A436687 BOOMERANG ASSEMBLY CAST

TELESCOPIC BOOM ASSEMBLY A436620

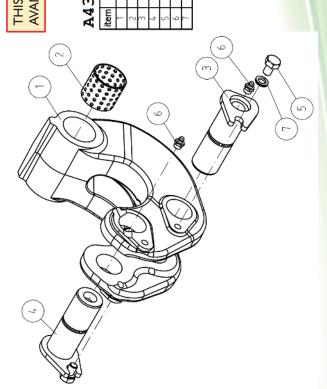
Bucket tilt cylinder housing.
Boomerang end of the
housing needs to be cut
smaller L=10 mm to make room
for new cast iron boomerang.
The purpose of the small cap is
to keep all debris and small rocks
away from the mechanism, not
to get those trapped inside.
Please see the pictures attached
